MODIFICATION TO DRB22-0859 APPROVAL FOR SINGLE FAMILY RESIDENCE

DRB FILE No. DRB25-1105

4,5,6 STAR ISLAND DRIVE

PURPOSE OF MODIFICATION:
SEEKING DRB APPROVAL OF 34 FT MAXIMUM BUILDING HEIGHT AS OF RIGHT UNDER CURRENT MIAMI BEACH RESILIENCY CODE

NEW VARIANCE REQUEST 04 - ACCESSORY STRUCTURE HEIGHT

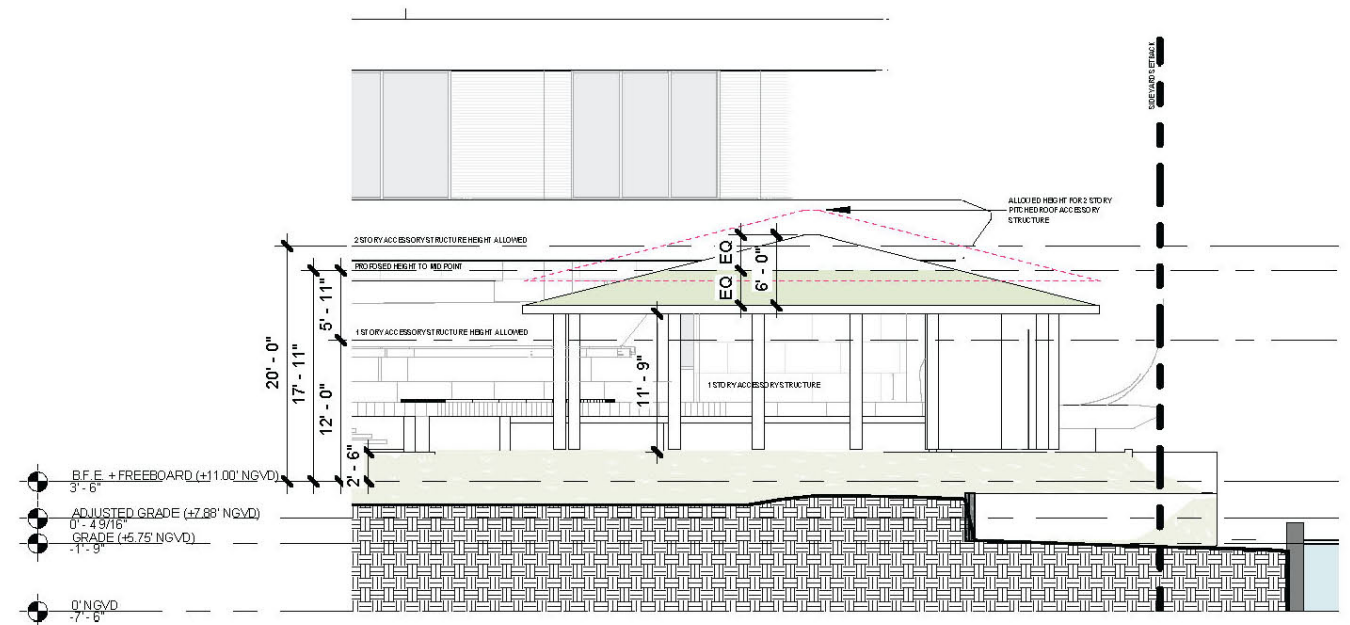
VARIANCE 04 :
 A VARIANCE FROM SEC. 7.2.2.3.b.12.B. TO EXCEED BY 5'-11" THE MAXIMUM HEIGHT ALLOWED OF 12'-0" IN ORDER TO CONSTRUCT A ONE STORY ACCESSORY STRUCTURE UP TO 17'-11" HIGH.

NEW VARIANCE REQUEST 05 - FRONT YARD DRIVEWAY PAVING

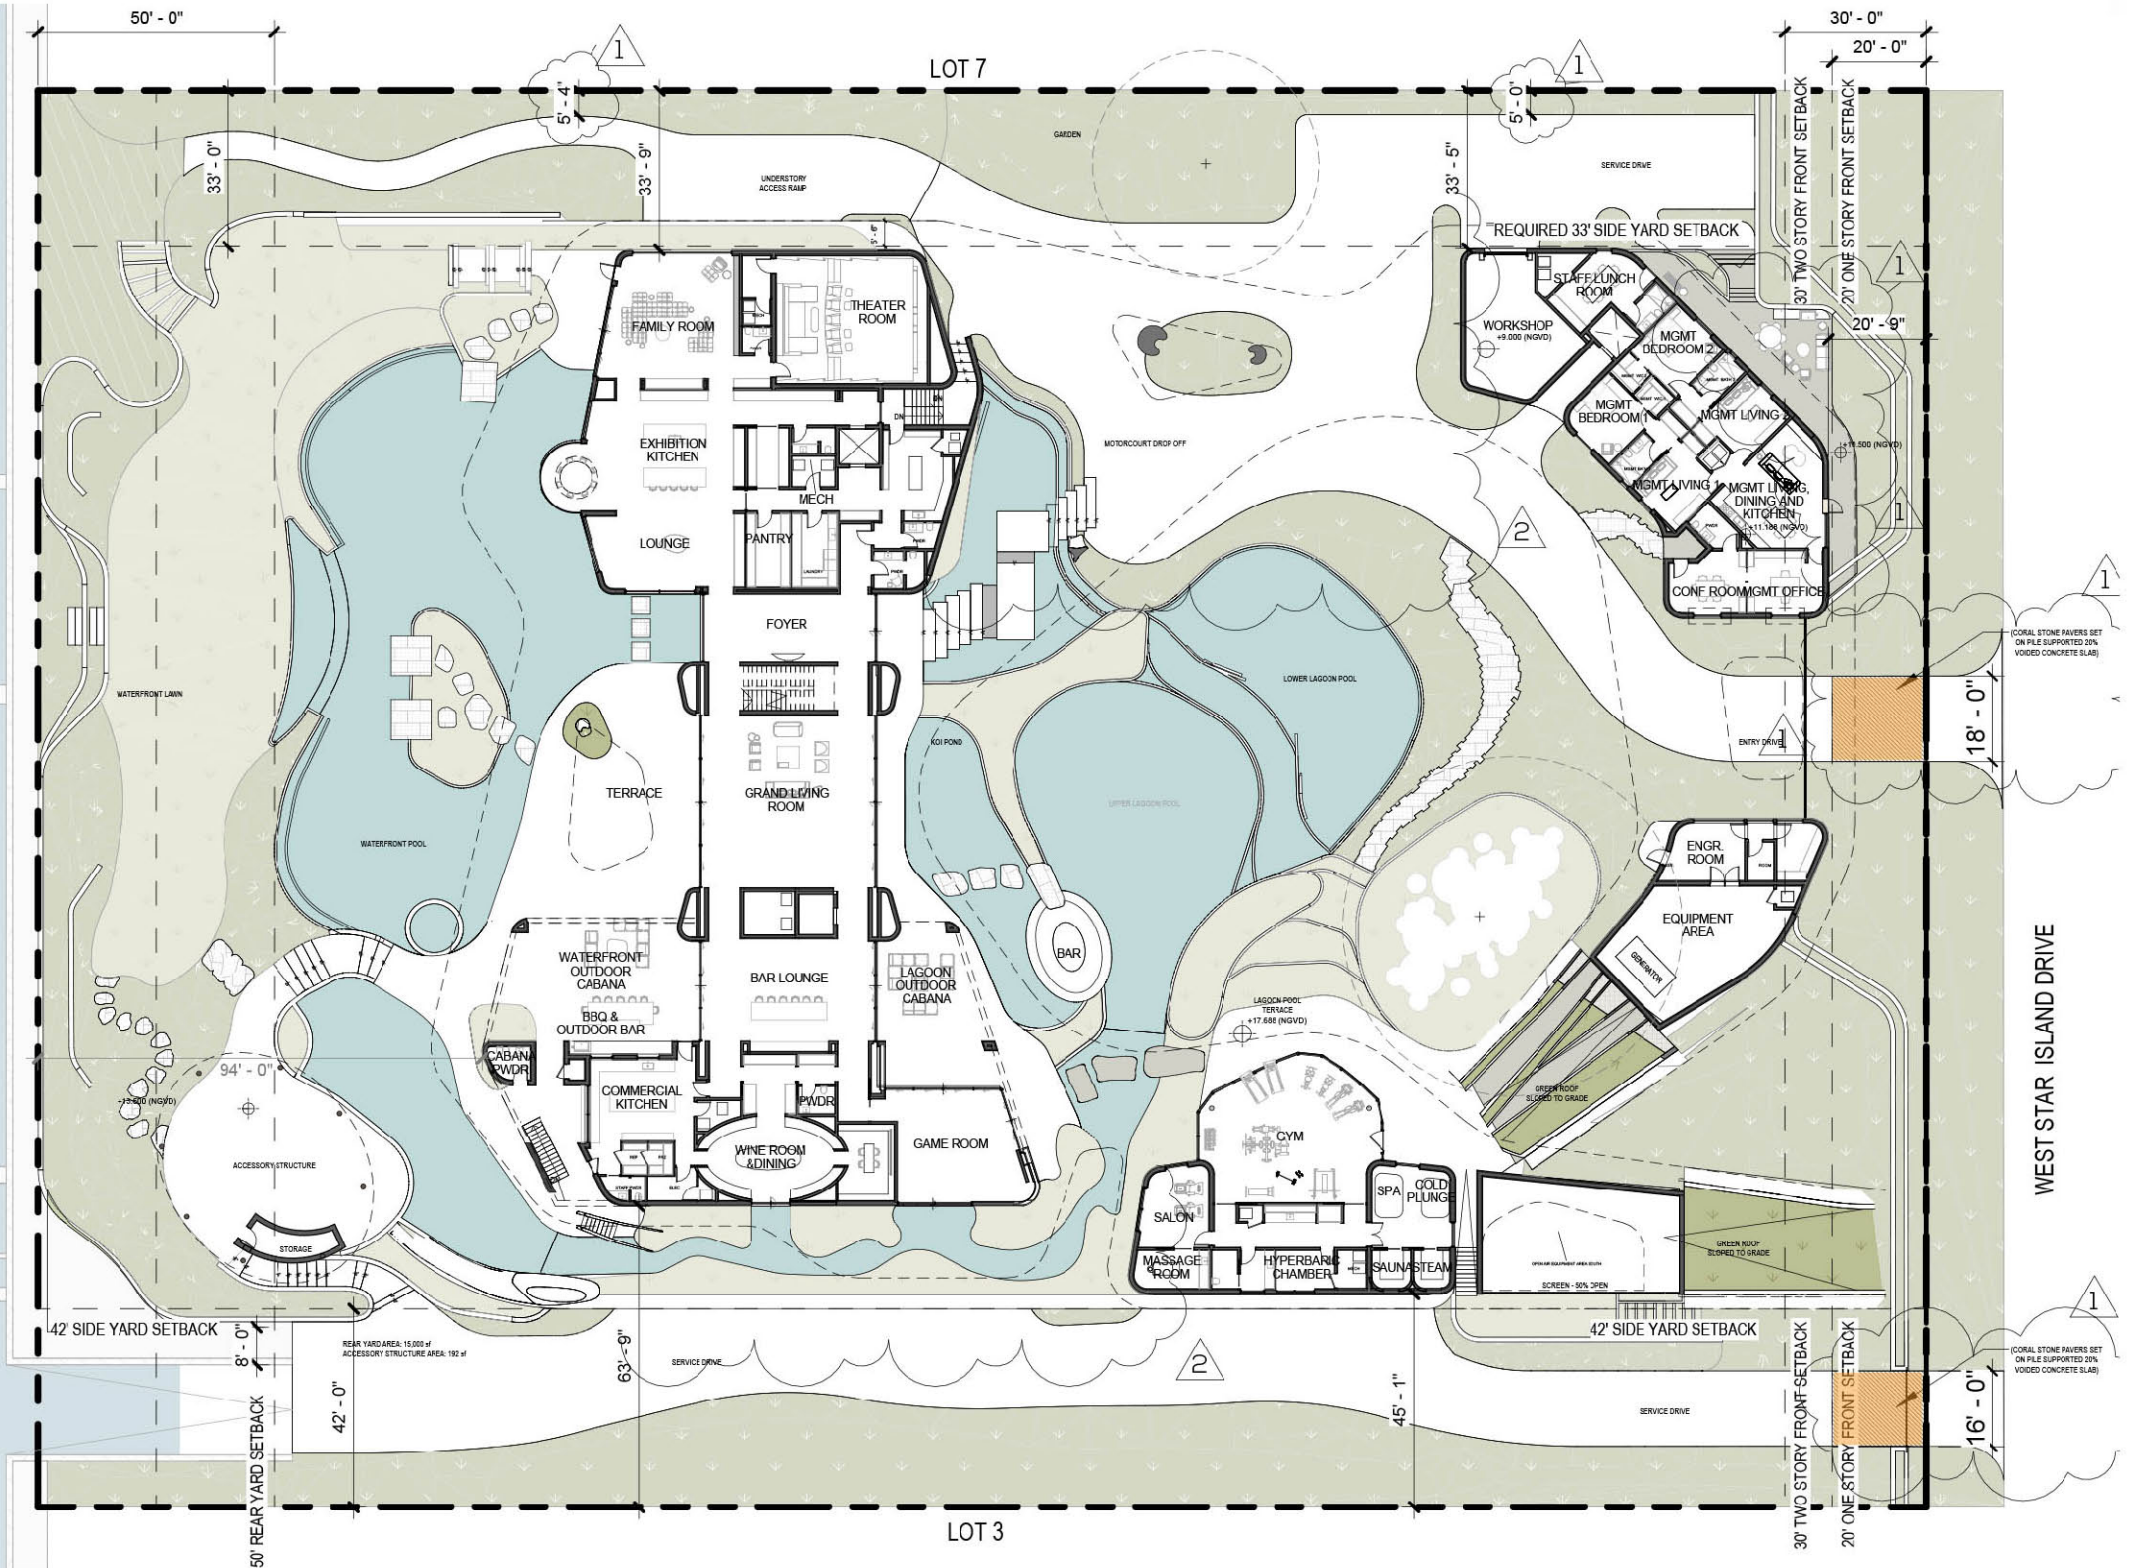
A VARIANCE FROM SEC. 7.2.2.3(b)(1), FOOTNOTE (6) FOR THE DRIVEWAY PAVING LOCATED WITHIN THE FRONT YARD TO CONSIST OF LARGE FORMAT CORAL STONE PAVING SET ON CONCRETE GRID SYSTEM TO PREVENT CRACKING OF 3'x6'x8" PAVER.

NEW VARIANCE REQUEST 06 - UNDERSTORY PAVING

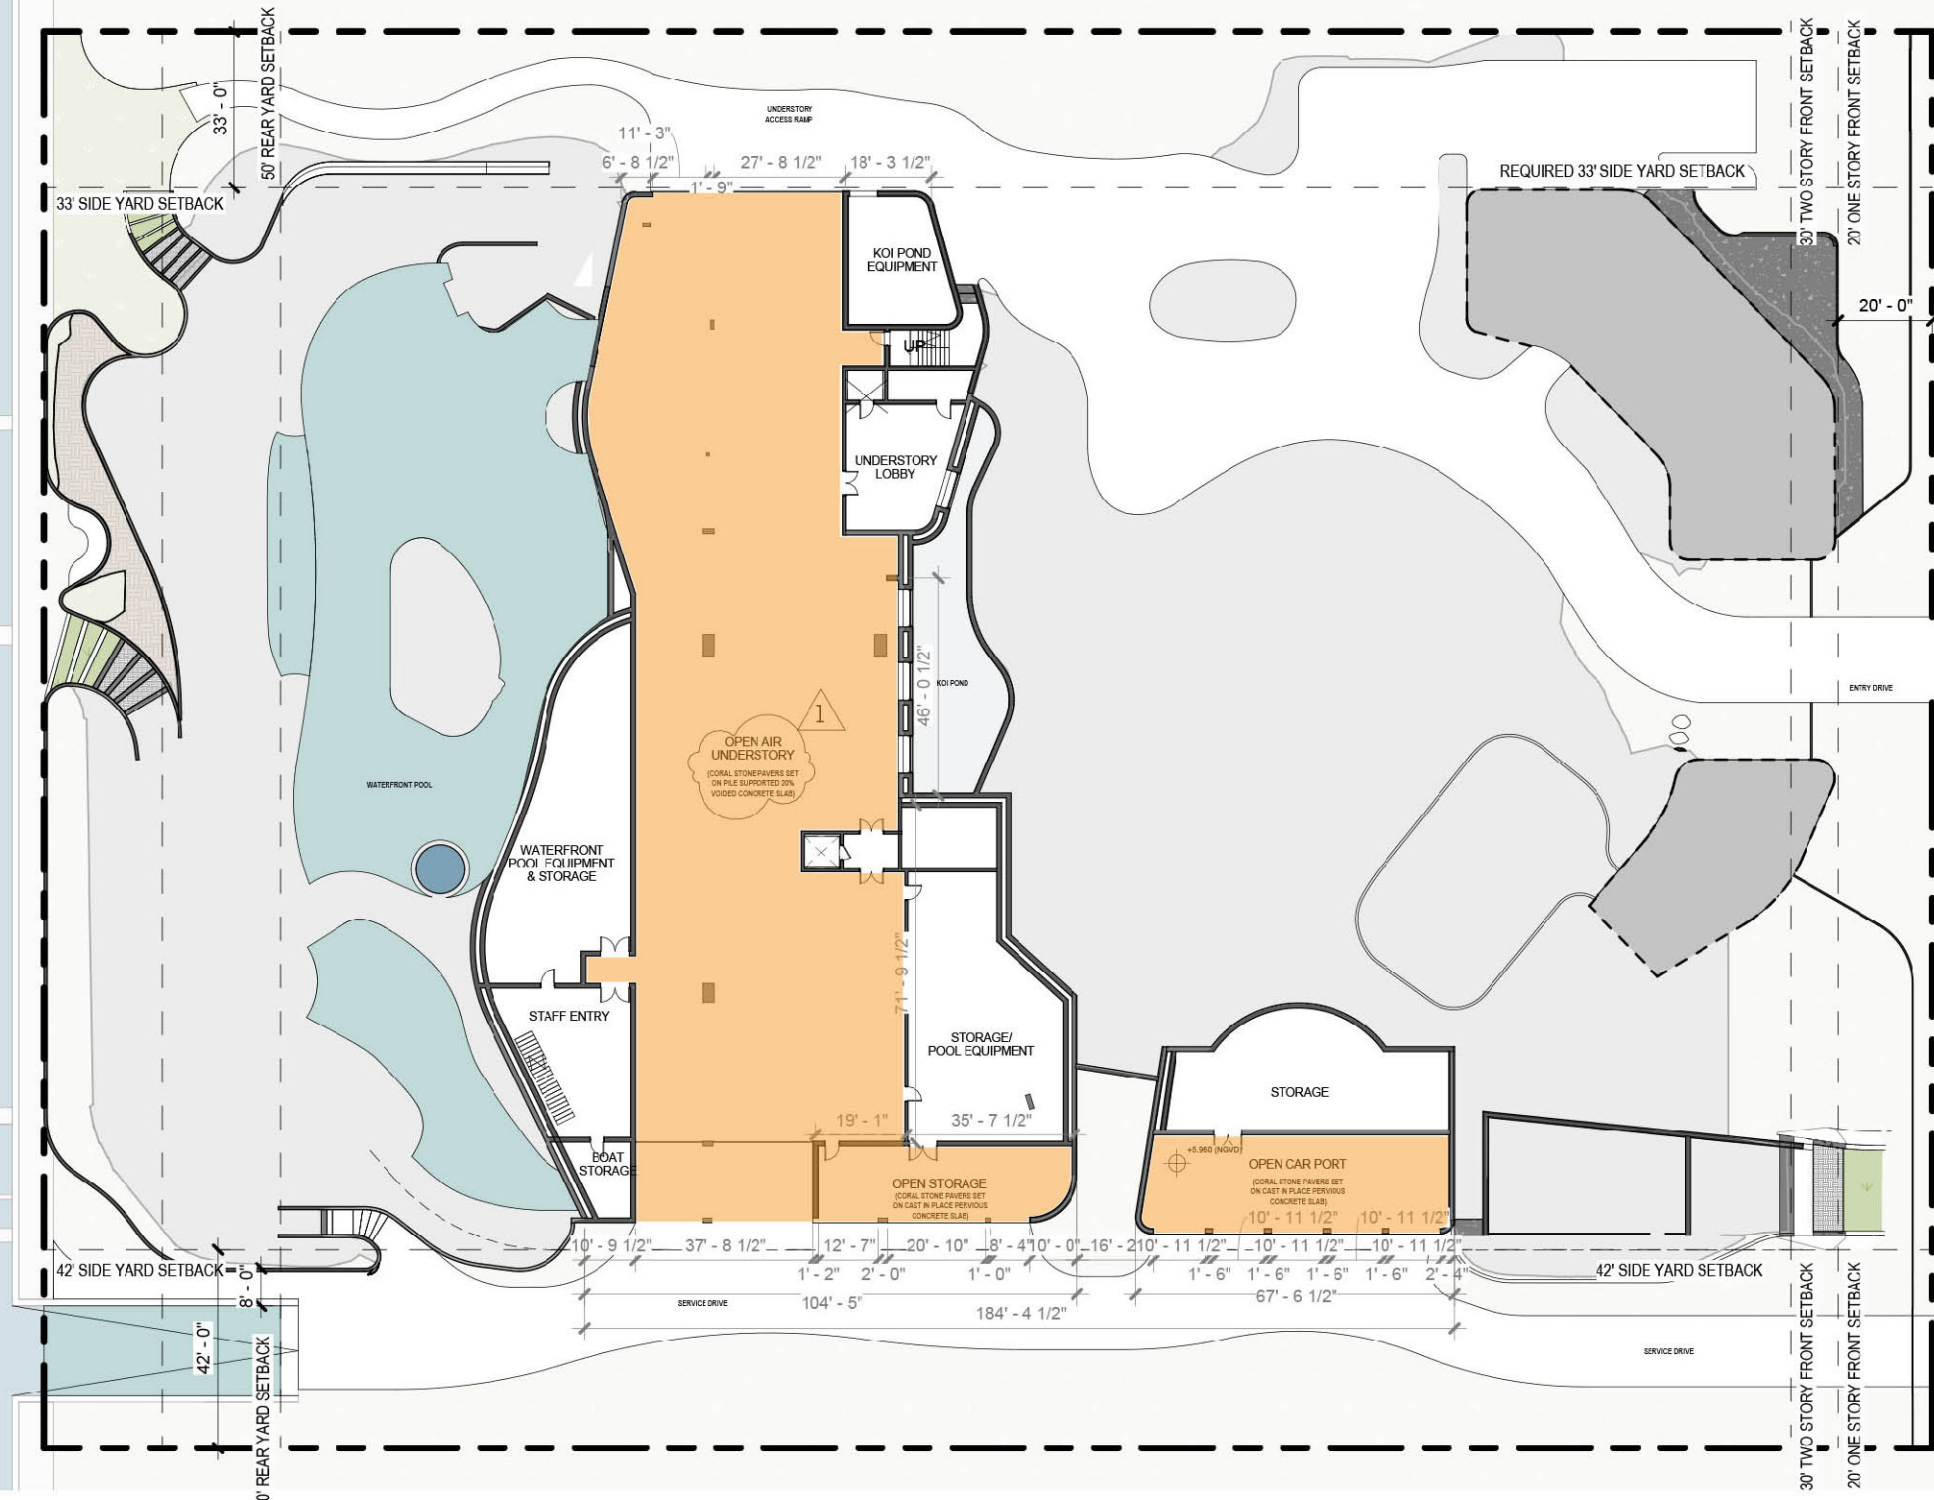
A VARIANCE FROM SEC. 7.2.2.3(b)(6) (G) FOR THE PAVING LOCATED WITHIN THE UNDERSTORY TO CONSIST OF LARGE FORMAT CORAL STONE PAVING SET ON CONCRETE GRID SYSTEM TO PREVENT CRACKING OF 3'x6'x8" PAVER.

POST FILING MODIFICATION TO FIRST FLOOR PLAN

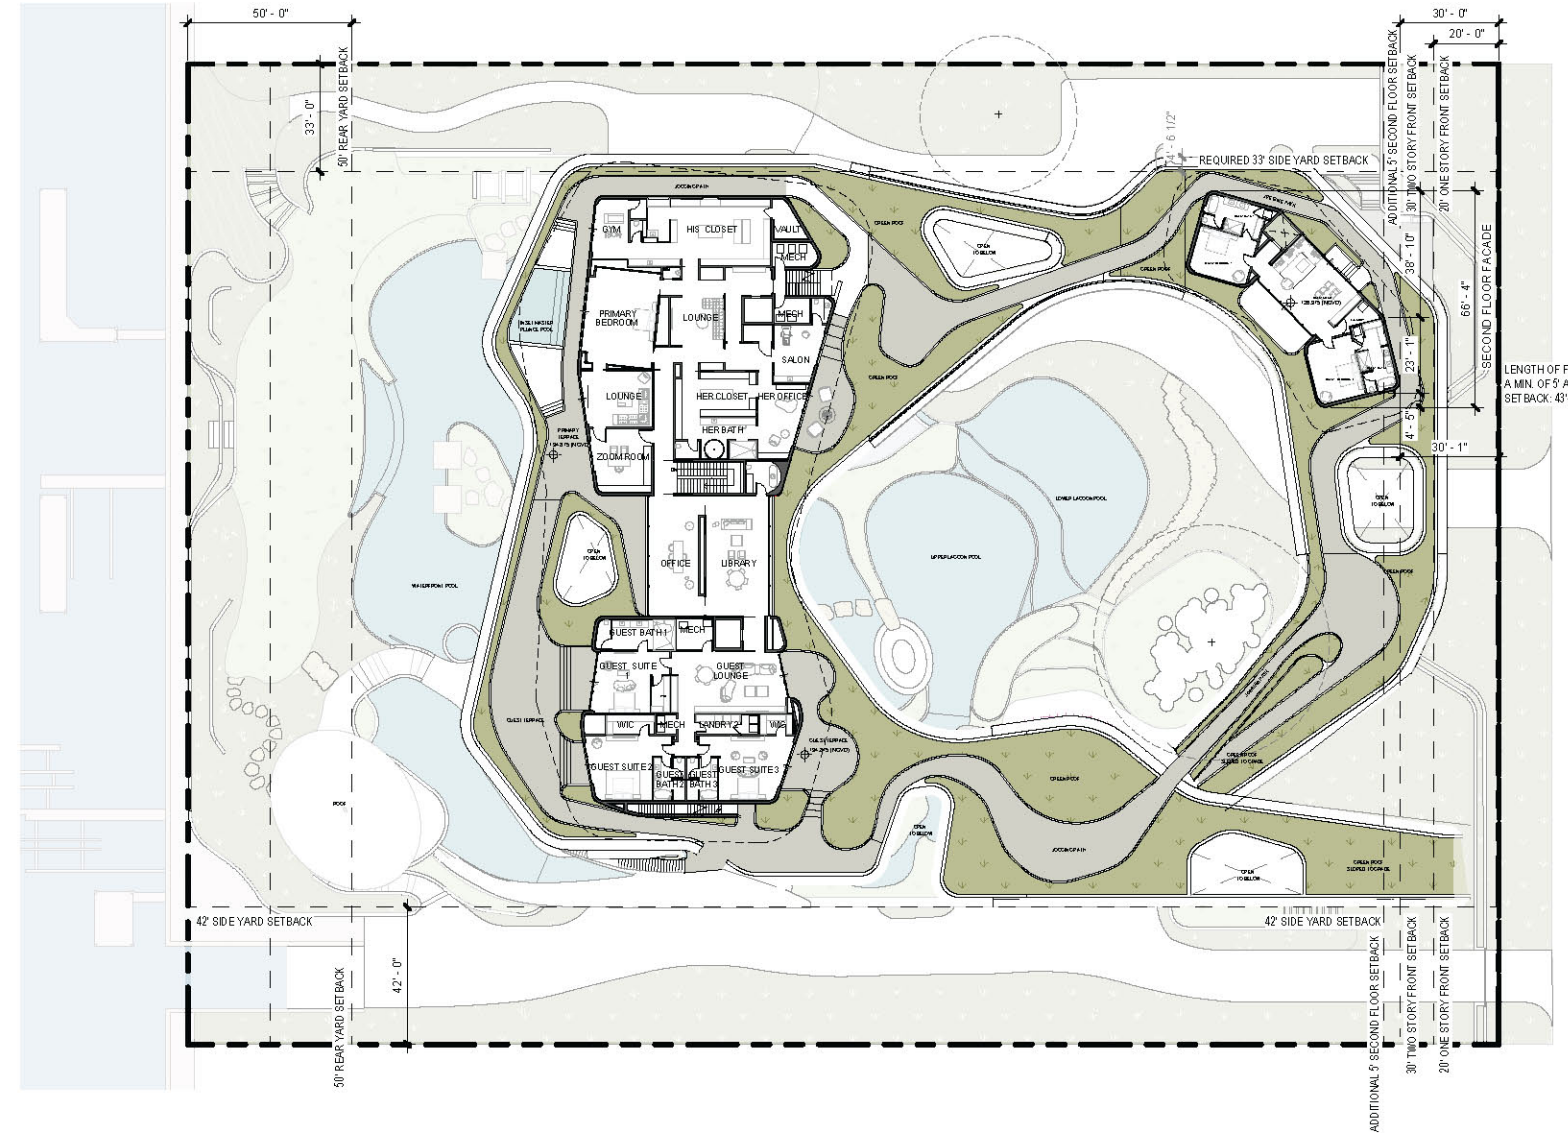
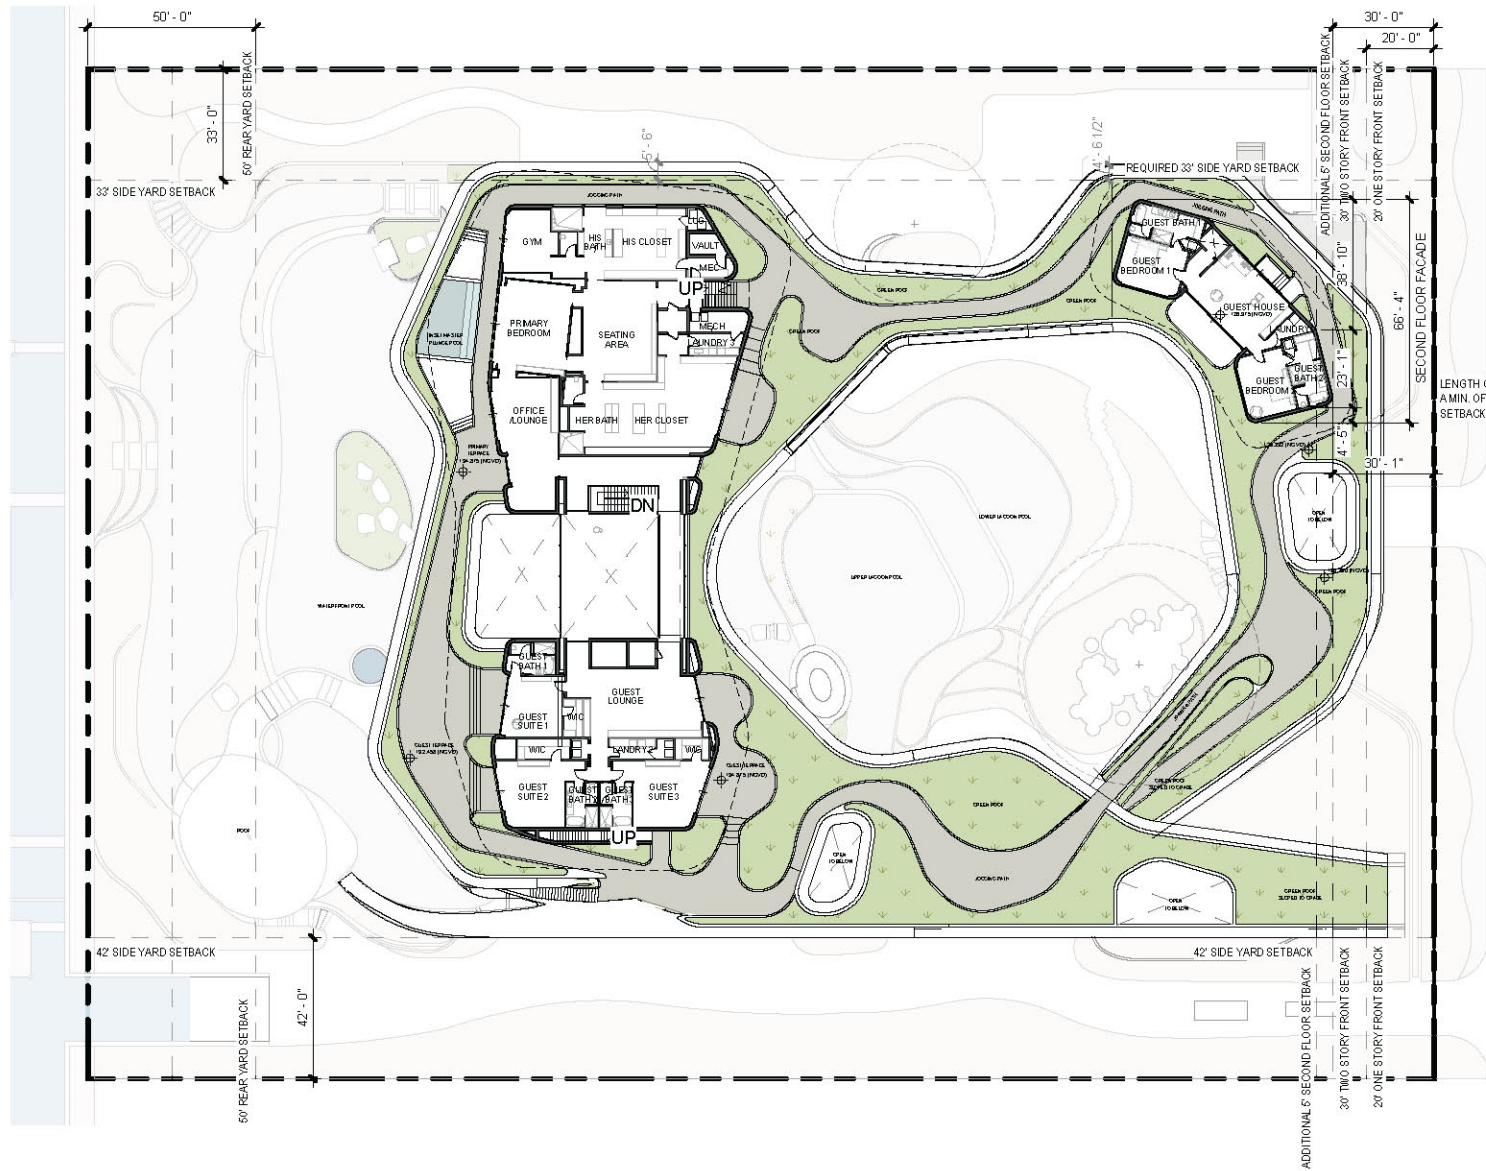
PROPOSED MODIFICATION
